Product Change Notification

PCN-IFC-433-2017

In our continuing efforts to optimize our products, the CES snap frame, sealing frames, and flat gaskets will be modified as follows:

Previous Product	New Product
 <p>angespritzte Dichtung / injected gasket</p>	 <p>Flachdichtung / flat gasket</p>

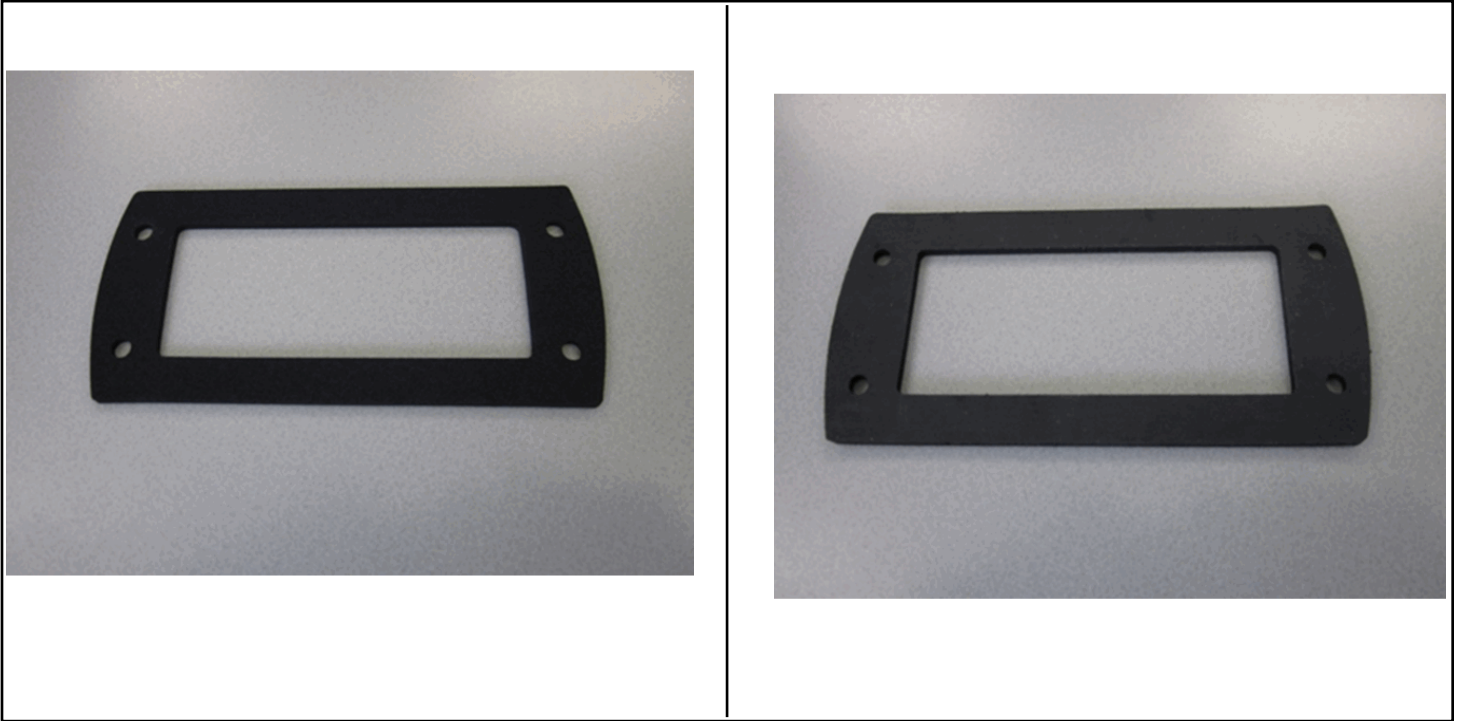
- 1) Snap Frame: The shape has been modified and the flat gaskets will be made from NBR instead of injected gaskets.
- 2) Sealing Frame with Latch: The flat gasket will be changed from foam rubber to NBR and the sealing lip will be now be cogged at the points where the left and right side of the frame makes contact.
- 3) Sealing Frame with Screw Locking: The flat gasket will be changed from foam rubber to NBR.
- 4) Flat Gasket Spare Parts: The flat gasket will be changed from foam rubber to NBR.
- 5) Sealing Frame with Cones: The flat gasket will be changed from foam rubber to NBR.
